Access Compliance Report

Public Rights-of-Way (Curb Ramps)

Intersection ID: 44781	Main Street: SILVER_CRESCENT_DR	Cross Street: TOMLIN_WAY_CT	Location: S
ADA ID: A09F8527AE9E	Ramp Type: PerpDiag	Initial Pass/Fail: Fail	Overall Compliance: No
Severity Score: 12.5			
Codes/Mitigation Info/Possible Solution		Field Measurements/Component Compliance

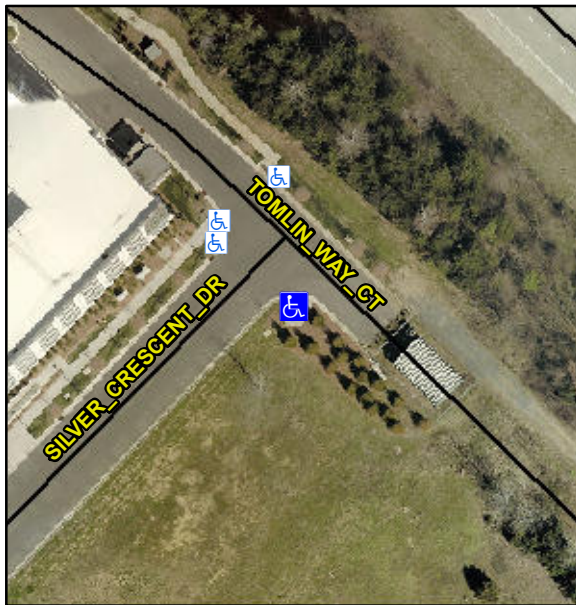
Compliance	Description	Data	Compliance	Description	Data
N/A	Ramp Length (in)	103.0	No	Ramp Slope (%)	8.5
Yes	Ramp Width (in)	60.0	Yes	Ramp XSlope (%)	1.4
N/A	Flare Type LT	N/A	N/A	Flare Type RT	N/A
N/A	Flare Slope LT (%)	N/A	N/A	Flare Slope RT (%)	N/A
N/A	Flare Traversable LT?	N/A	N/A	Flare Traversable RT?	N/A
N/A	Landing Length (in)	N/A	N/A	DWS Provided?	N/A
N/A	Landing Width (in)	N/A	N/A	DWS Contrast?	N/A
N/A	Landing Slope (%)	N/A	N/A	DWS Length (in)	N/A
N/A	Landing X Slope (%)	N/A	N/A	DWS Full Width?	N/A
N/A	Landing Curb? (Y/N)	N/A	N/A	DWS Offset (in)	N/A
N/A	Shared Landing?	N/A			
N/A	Gutter Ponding?	N/A	N/A	Gutter Slope (%)	N/A
N/A	Gutter Lip Ht (in)	N/A	N/A	Gutter X Slope (%)	N/A
N/A	Painted X Walk1?	No	N/A	Painted X Walk2?	No
	X Walk 1 Direction	To NE		X Walk 2 Direction	To NW
N/A	X Walk 1 Width (in)	N/A	N/A	X Walk 2 Width (in)	N/A
	X Walk 1 Slope (%)	4.8		X Walk 2 Slope (%)	4.3
	X Walk 1 X Slope (%)	3.7		X Walk 2 X Slope (%)	4.2

N/A	Ramp inside XWalk1?	N/A	N/A	Ramp inside XWalk2?	N/A
	Road Slope (%)	2.1	N/A	Clear Space?	N/A
	Road X Slope (%)	4.2	N/A	Clear Space to XWalk (in)	N/A
N/A	Any Obstructions?	N/A	N/A	Storm Grate/Utility Hazard?	N/A
	Obstruction Type			Storm Grate/Utility Type	
		N/A			N/A
			Yes	Surface Condition? (G/P)	Good

Remove & Replace Curb Ramp With Two New Directional Ramps or Equivalent.

R304.2.2
